Product Change Notification / KSRA-18BGHS695

CCB 4559 Initial Notice: Qualification of SIGN as a new assembly site for selected SST39LFxxxx and SST39VFxxxx device families available in 48L TSOP (12x20mm) package.

CCB 4559
Pre and Post Change Summary
PCN # KSRA-18BGHS695

Lead frame Comparison

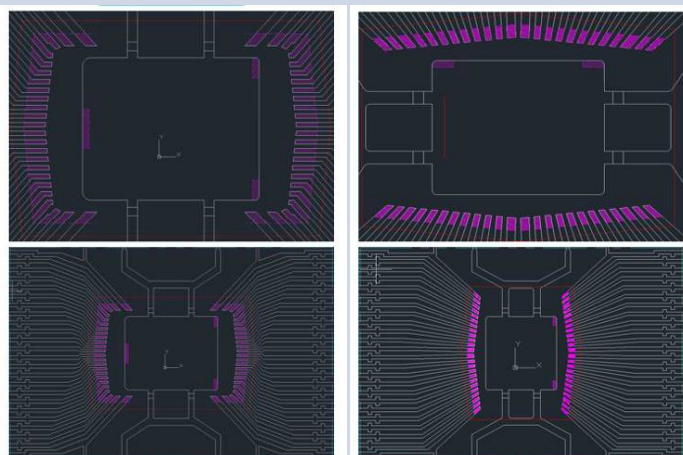
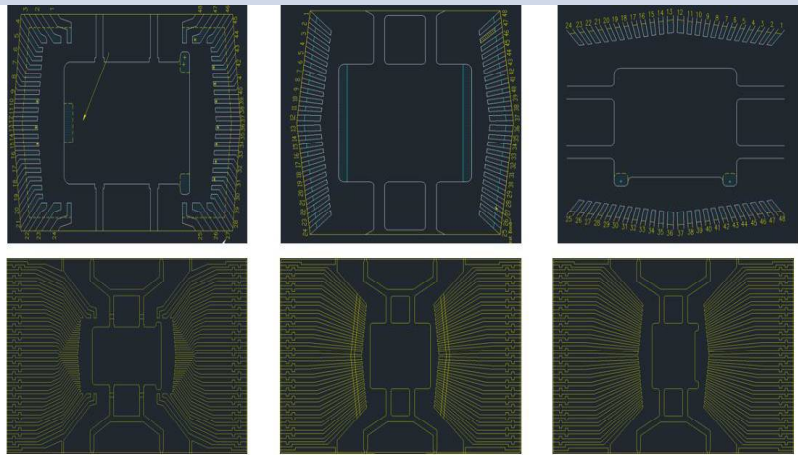
Pre Change
LPI

Post Change
SIGN
